SECY-90-296

Subject: FINAL REPORTS OF THE NUREG-1150 REVIEW COMMITTEES: STAFF
COMPLETION OF FINAL NUREG-1150

Purpose: To transmit the final reports of the NUREG-1150 Peer Review
Committee, the American Nuclear Society's Special Committee
on NUREG-1150, and inform the Commission of staff plans to
complete and issue a final version of NUREG-1150.

Special Committee Review of the Nuclear Regulatory Commission's Severe Accident Risks Report (NUREG-1150)

Figure 3.7 Results of Analysis Progression for Surry and Zion Early Releases (Internal Events Only)

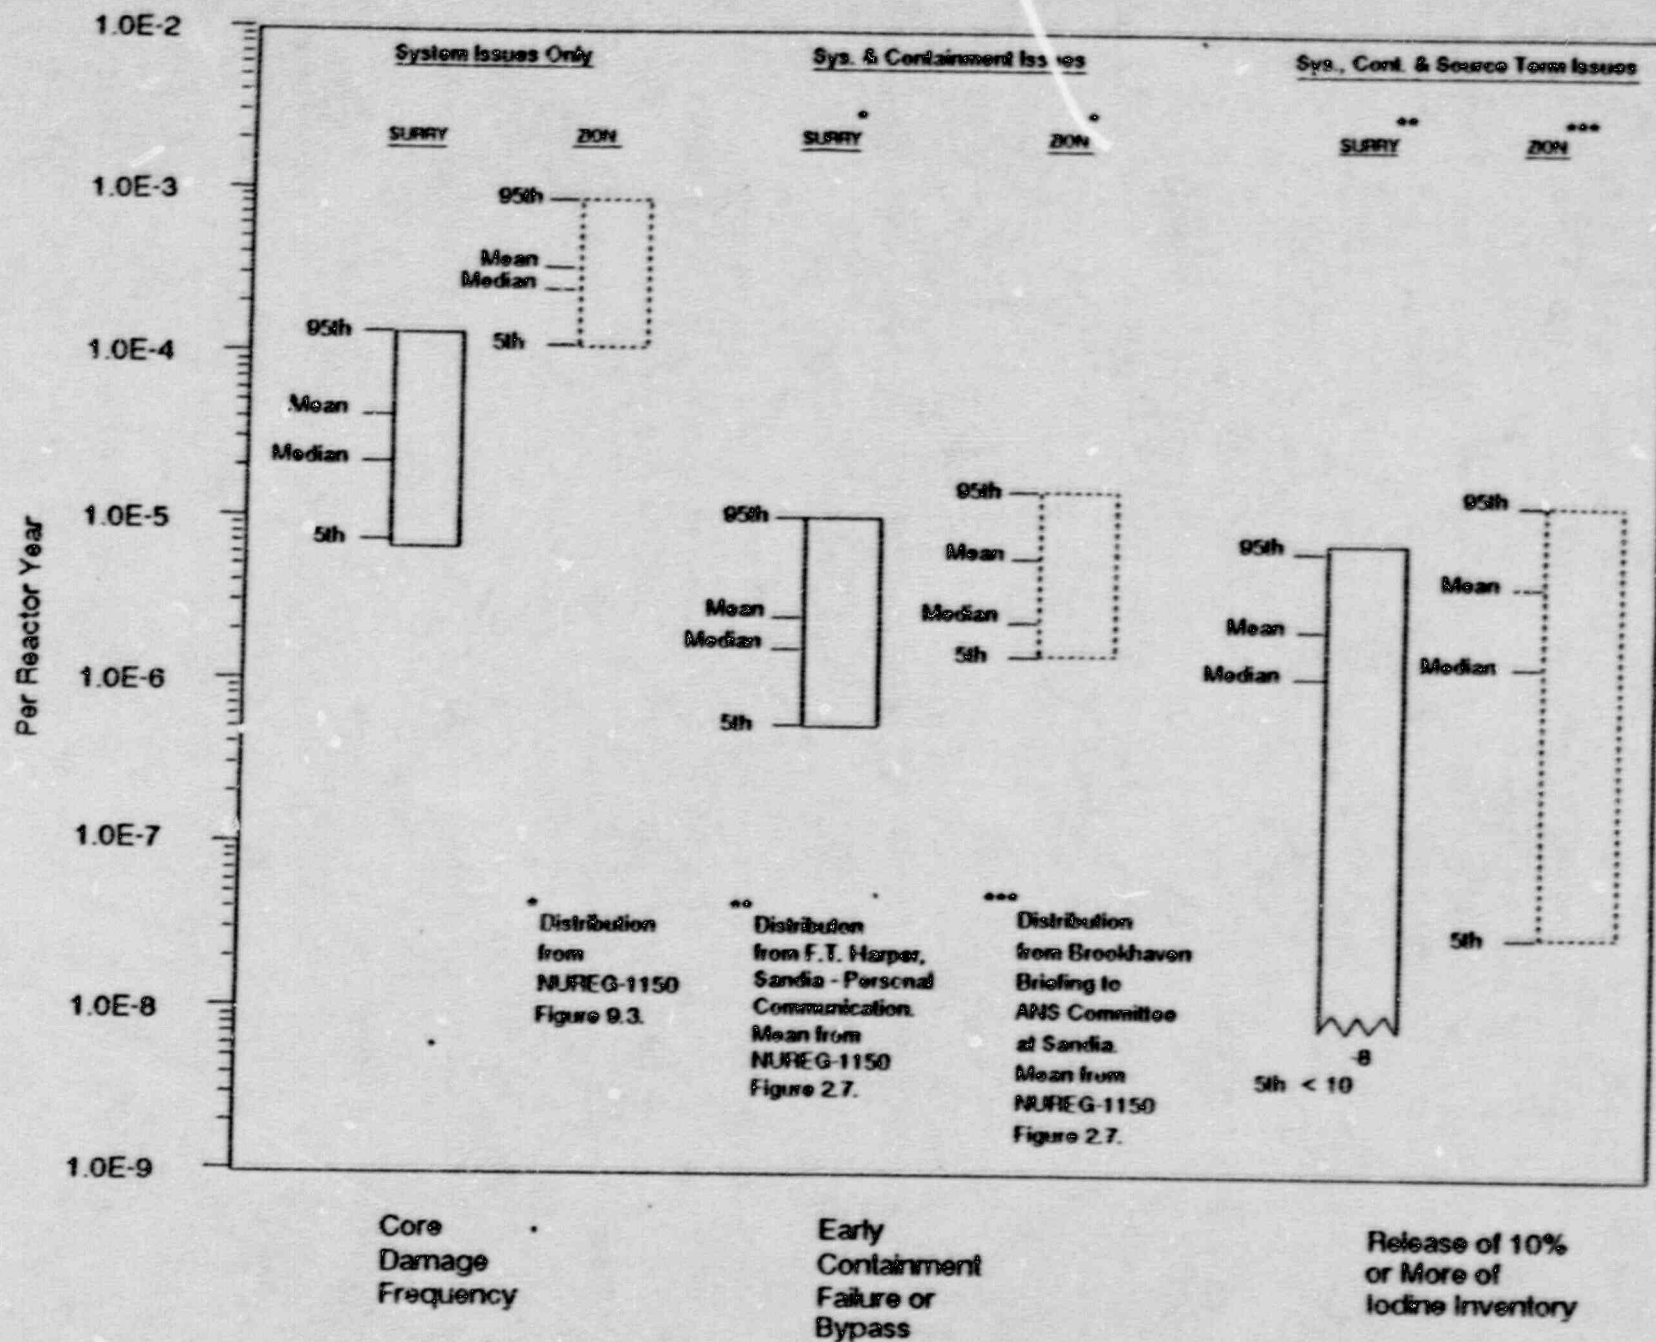
Although essentially the entire core damage frequency distribution for Zion falls above the comparable distribution for Surry, as indicated by the two bar graphs to the left in Figure 3.7, when the systems and containment issues are combined, as indicated by the bar graphs in the middle of this figure, the corresponding Zion and Surry distributions are quite comparable. Moreover, the range of uncertainty from the median to 95th percentile is not appreciably different from that for the systems only issues, i.e., no additional uncertainty is added to the upper half of the distribution. When the source term uncertainties are included, as is the case in the two bar graphs to the right in Figure 3.7, the range of uncertainty is virtually the same as for the two previous sets of bar graphs. In other words, the range of Fig. 3-7 uncertainty in source term does not mask the variation that occurs because of actual differences in accident progression behavior, at least for the more important upper half of the distribution for large releases, e.g., 10 percent or more of the iodine core inventory.

Figure 3.13 (from NUREG-1150, Figures 8.8 and 8.9)

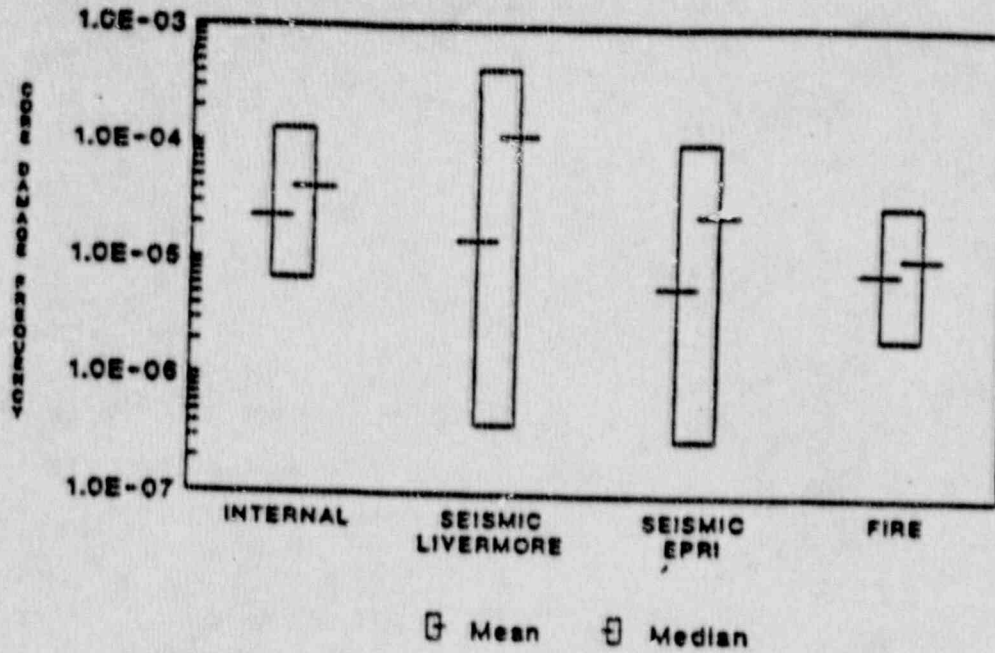
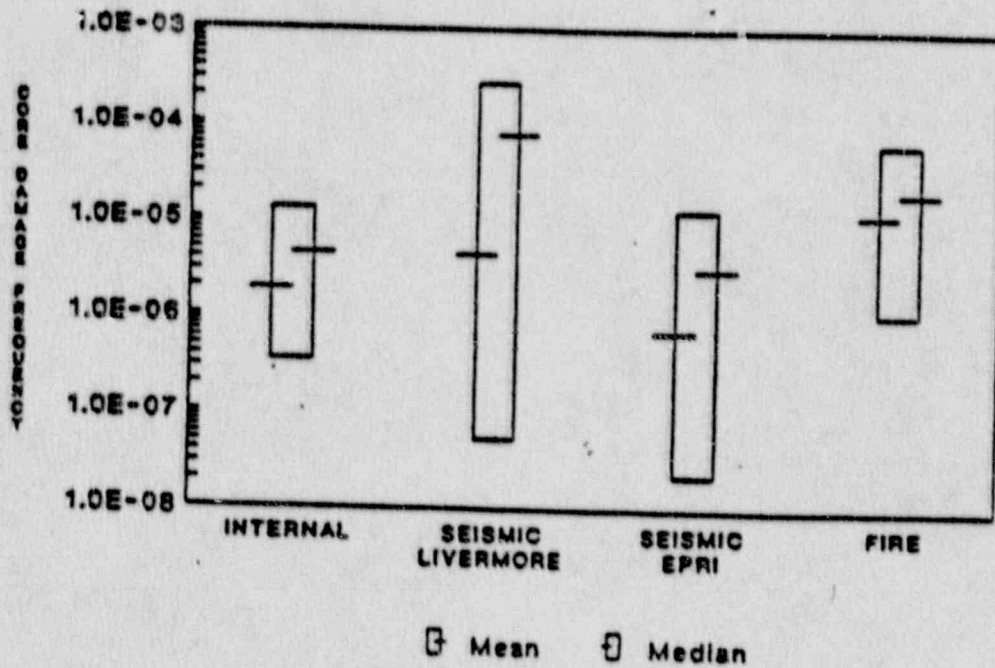
The relatively large core damage frequencies for fire initiators are a result of plant data showing a high frequency of fire incidence and the fact that there are locations where damage from a single fire could affect the performance of a number of vital systems, notably switchgear rooms. The fire analysts appear to have made a strong effort to determine actual conditions for fire likelihood at the two plants studied. Although plant experience (gathered from many plants, not just those being analyzed) was used to establish the fire initiation frequency, judgmental factors were used to determine whether a fire, once started, would persist and cause damage in spite of fire mitigation systems and

actions. It would seem that the same data base that was used for fire initiation could, and should, have been used to give a more realistic value of fire persistence.

Figure 4.2 Comparison of NUREG-1150 and WASH-1400 Cumulative Containment Failure Probabilities (Figures 9.6, 9.7 & 9.9 in NUREG-1150)

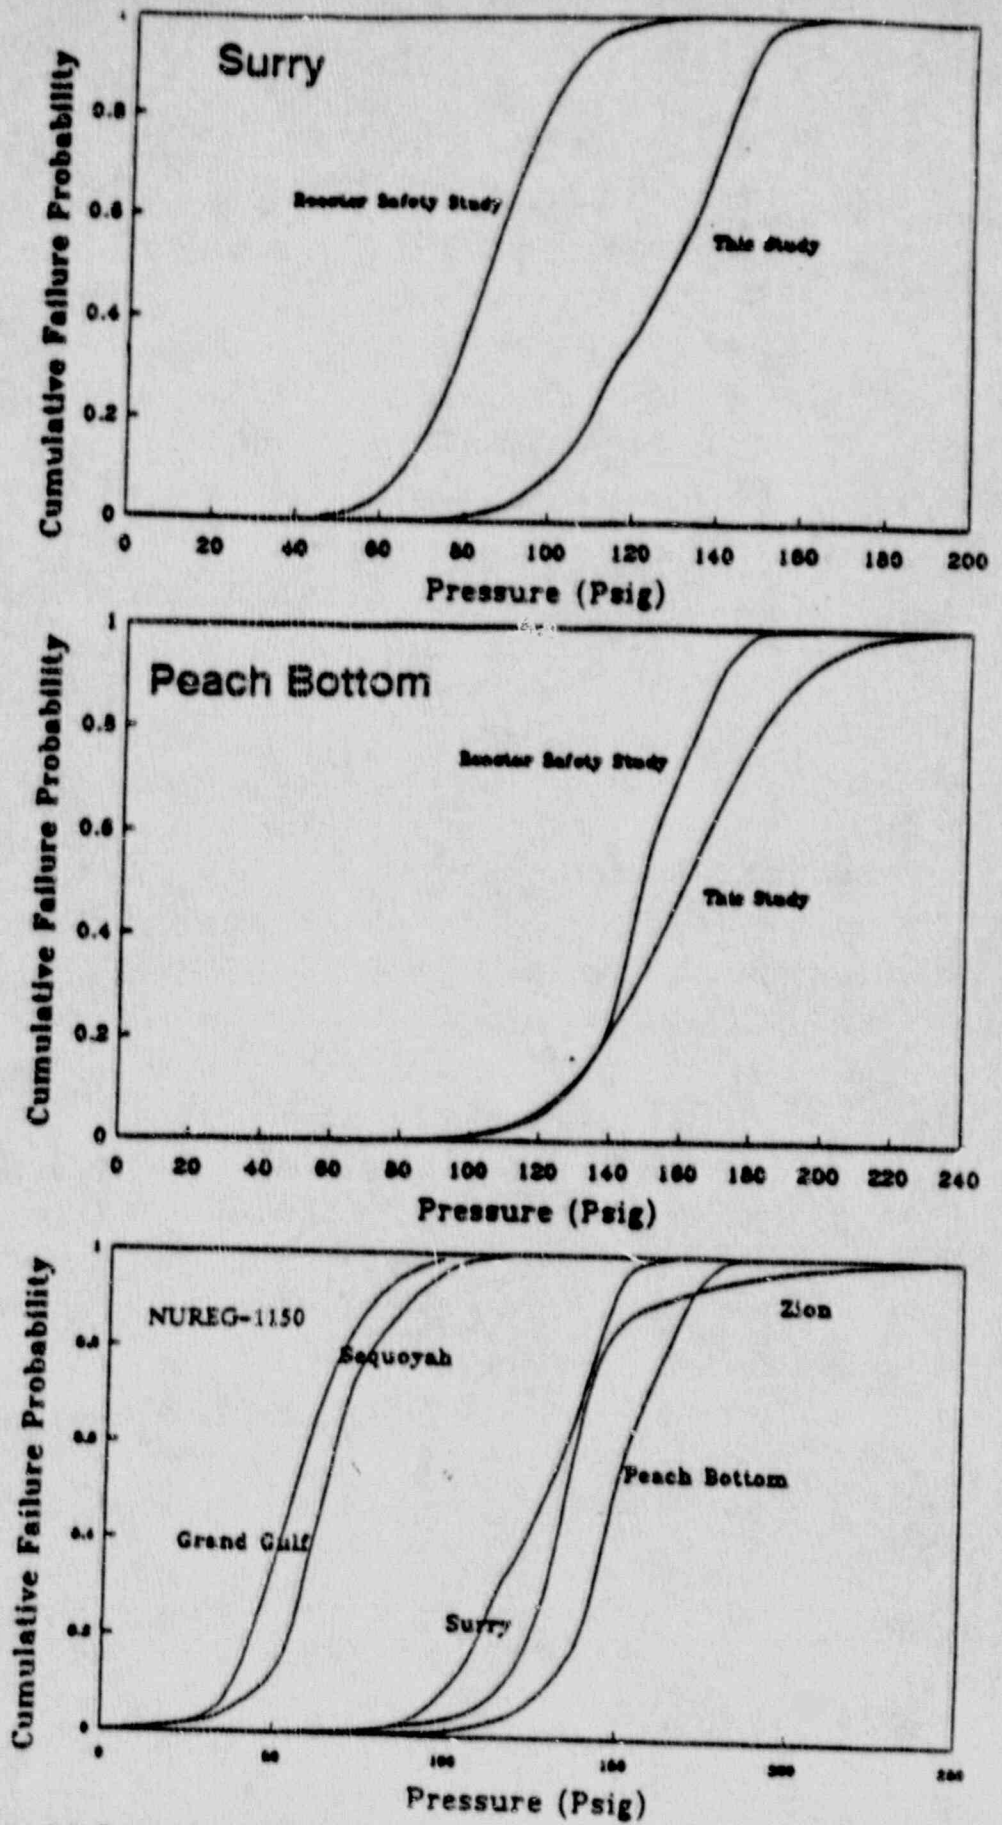
One major difference between WASH-1400 and NUREG-1150 is the fact that the Surry containment is shown to be considerably stronger than assumed in the earlier study, as evidenced by the comparisons of cumulative containment failure probability shown in the upper portion of Figure 4.2. (This figure is a reproduction of Figures 9.6, 9.7, and 9.9 from NUREG-1150). The curves in the upper portion of this figure indicate that the median cumulative containment failure pressure has shifted from approximately 80 to 130 psig.

The failure pressure curves for Peach Bottom in the center portion of Figure 4.2, indicate no substantive difference between the two studies with regard to the BWR Mark I containment response to static pressure. As shown in the lower portion of Figure 4.2, the Sequoyah and Grand Gulf cumulative containment failure probabilities increase much more rapidly with increasing pressure than for Surry, Zion and Peach Bottom, owing to the much lower design pressures for these two plants. Whether there is containment failure due to overpressure is a function of the loads imposed and the containment response. Much more is now known concerning all aspects of severe accident progression, including pressure loads and response, than was available at the time of the Reactor Safety Study.

Figure 4.7 Comparison of Results of Analysis Progression for Early Releases in NUREG-1150 and WASH-1400

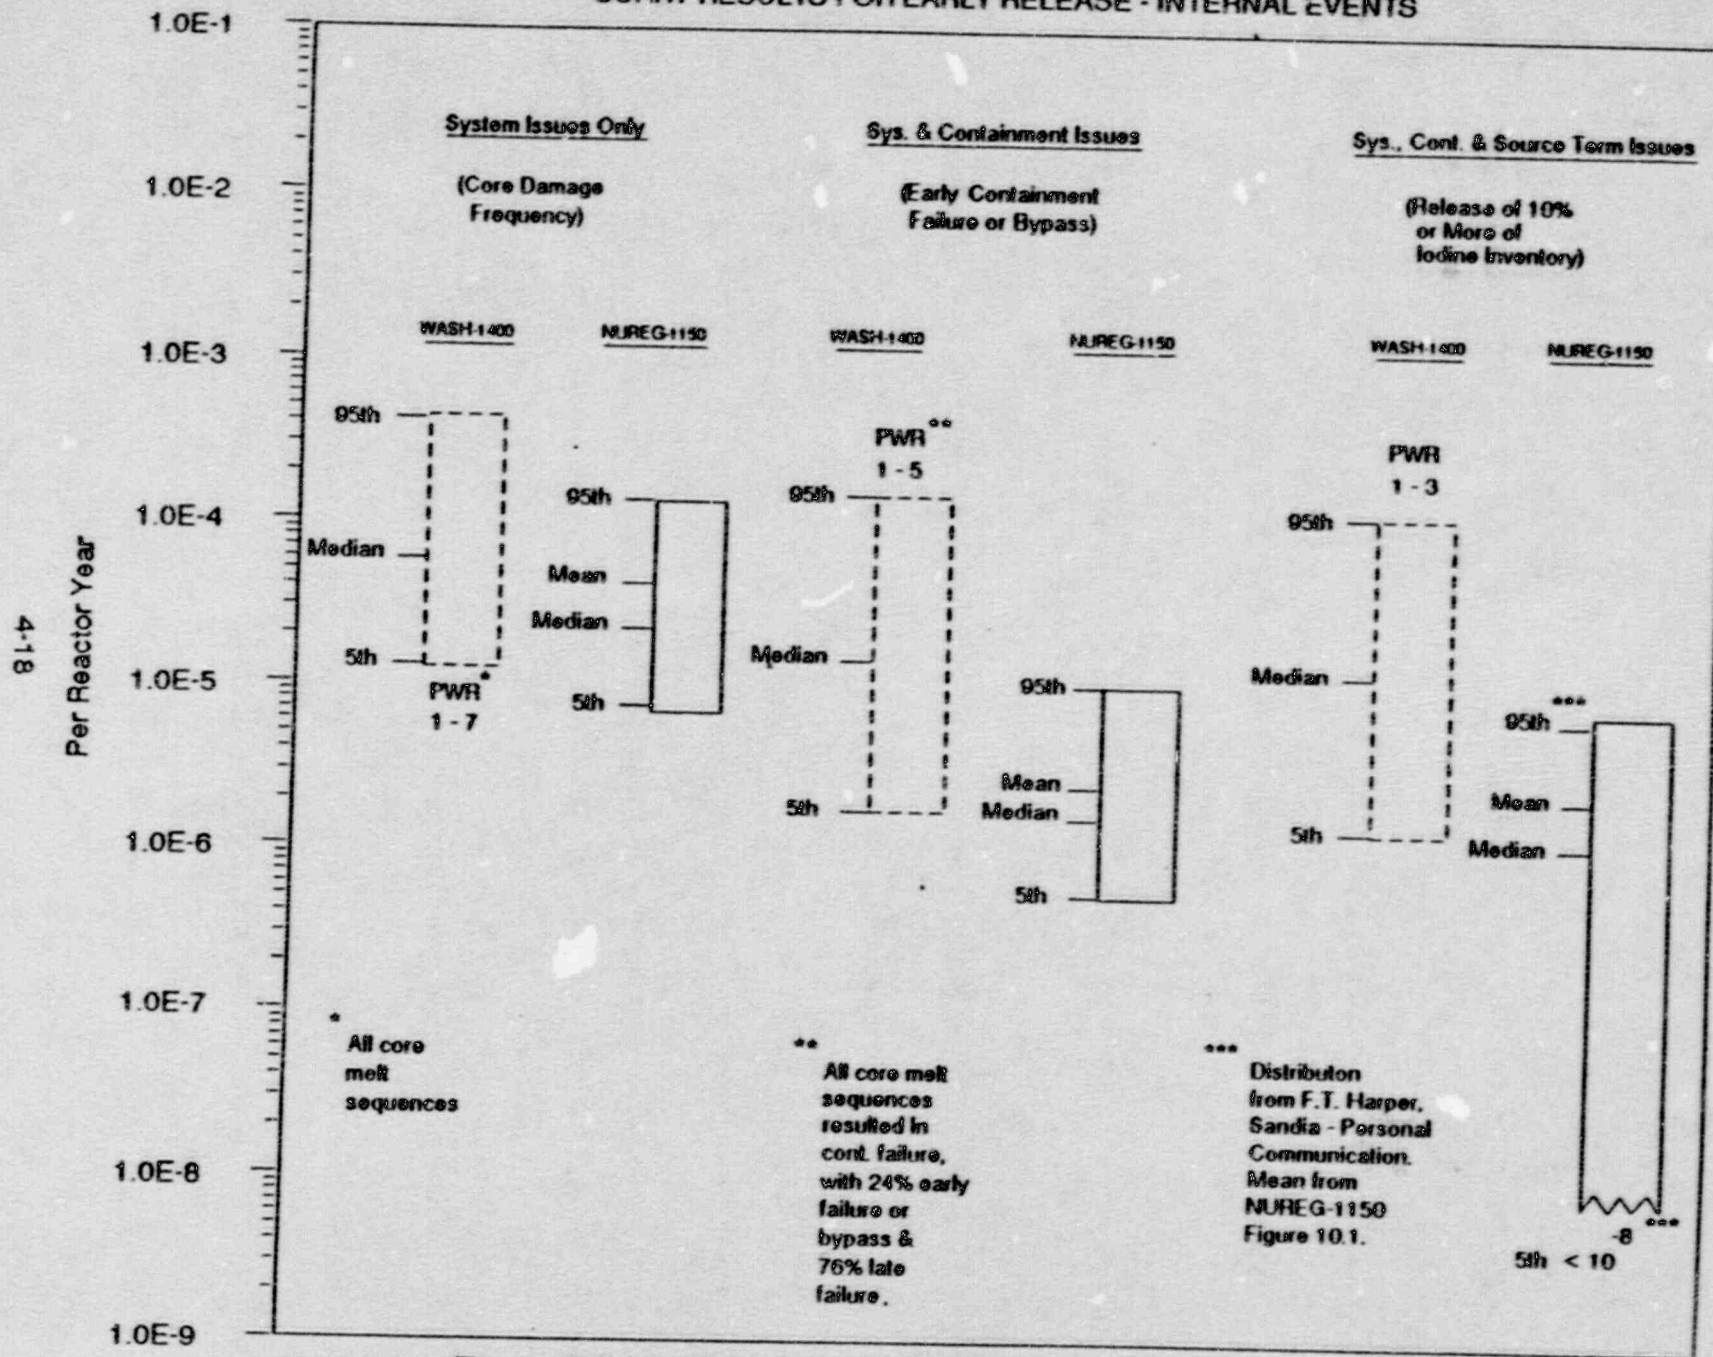
Several observations from the data presented in Figure 4.7 follow.

- When systems and containment issues are combined, as in the case for the bars in the center of the figure, the median frequency for NUREG-1150 is observed to be approximately an order of magnitude lower than WASH-1400 and the range of uncertainty is substantially smaller than in the earlier study.
